**An objection to the application to erect a garden shed at 29 Dartmouth Park Road NW5 1SU – application 2017/6068/P - from the Bellgate Mews Residents Association.**

**Re - Application 29 Dartmouth Park Road NW5 1SU - 2017/6068/P**

**Figure 1** Section through garden of 29 and Bellgate Mews proposal shown in red hatch.

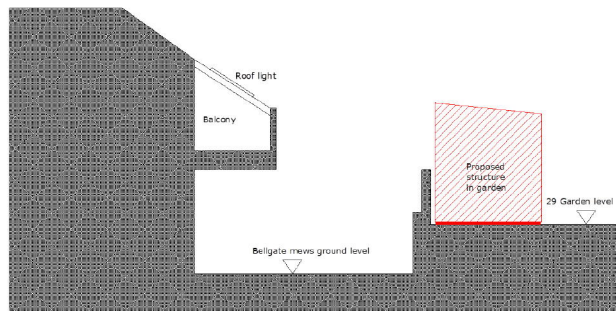
- 1.3 The application seems to be missing key information, we would argue, because this would reveal the true impact of the proposal on the neighbouring properties and the conservation area as a whole. The drawings both fail to show context in respect of the buildings around the proposal and deliberately clip the views or omit to show key information. There are lines that allude to fences and screening that does not exist. The actual wall between garden and the mews is not shown and is fudged with a fake fence line, giving a misleading impression that it is higher than it is, and thus to the amount of the proposed structure that will be above the wall line. There is also no design and access statement. We have provided below what we believe is the missing section taken front to rear through the wall with the mews to illustrate our understanding of the proposal in figure 1. Rear and flank elevations are also omitted. We hope this will make the point that that the missing information is more than an administrative oversight. We feel the Architects are fully aware of the nature of the information on this drawing as they have even omitted their title block from

- 3.1 Size, bulk and scale. The proposal, although drawn as building at the end of a residential garden, in fact sits in an elevated position (ground level 1.5m above street level in mews) directly in front of habitable room windows (4.3m). The massing and scale will produce an oppressive and overbearing sense of enclosure to the front of the houses in the mews. This is further exacerbated by the choice of materials. Even though from the applicant's side they have chosen a Western Red Cedar board, on the mews side this is plywood with creosote. That is not to say, a change of material in this area would change the comments made but it does show a less than neighbourly approach by the applicant.
